Kenai Hydro, LLC

RE: Revised Project Facilities and Operations Description for the Grant Lake Hydroelectric Project (Nos. 13212-001 and 13211-001) and Updated Filing Schedule

Attachment 1: Revised Project Facilities and Operations Description

Attachment 1
Grant Lake Project (FERC No. 13211/13212)
Revised Project Description

Figure 3.2-1. Proposed Project facilities, approximate access and transmission road location, and land ownership.

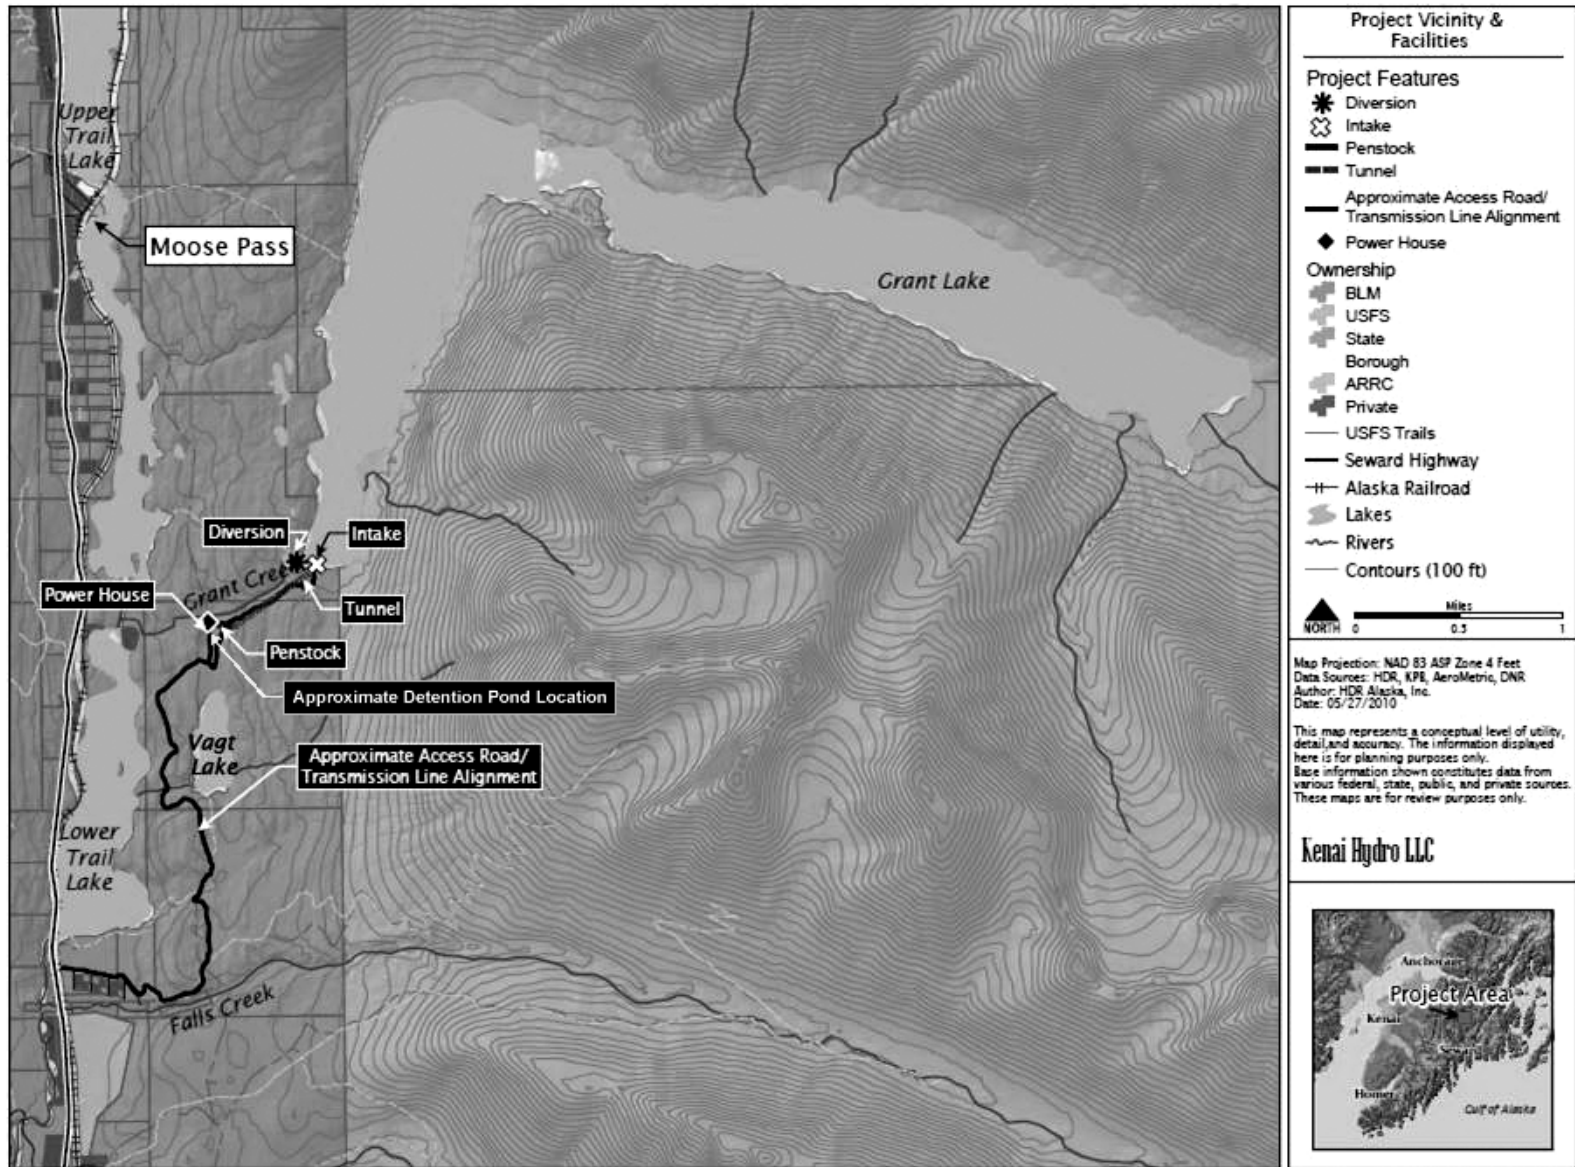
Land ownership and the proposed locations for Project facilities are shown in Figure 3.2-1.

The proposed Project is comprised of a diversion dam at the outlet to Grant Lake (under consideration), an intake structure in Grant Lake, a tunnel, a surge tank, a penstock, a powerhouse, a tailrace detention pond, a switchyard with disconnect switch and step-up transformer, an overhead or underground transmission line, and a pole-mounted disconnect switch where the line intersects the existing City of Seward distribution line and access roads.
